~ Work Order ID 96723

Item Name: Crosstube Fwd

DRAWING NO. D206-667-143	TITLE CROSSTUBE ASS'Y (206L HIGH FWD)	REV. C	DART AEROSPACE LTD ENGINEERING ORDER		D.E.O. NO. D206-667-143-C-1	SHEET NO. SHEET 1 OF 1	SCALE NTS
DRAWN 9P	CHECKED ASS	MFG. APPR. 108	APPROVED MD	DE APPR. H			
DATE 11.07.15	DATE 11.07.20	DATE 11.07.21	DATE 11/07/21	DATE 11.07.21

**DETAIL P**  
BONDING STRAP INSTALLATION 2 PL

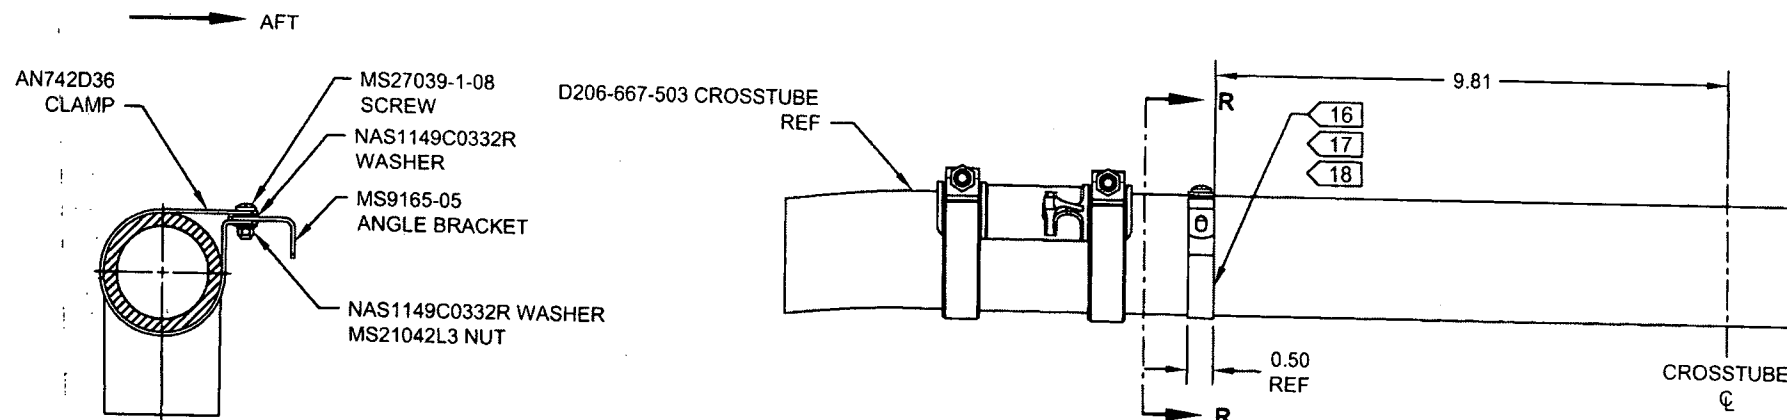
ADD ELECTRICAL GROUNDING STRAP
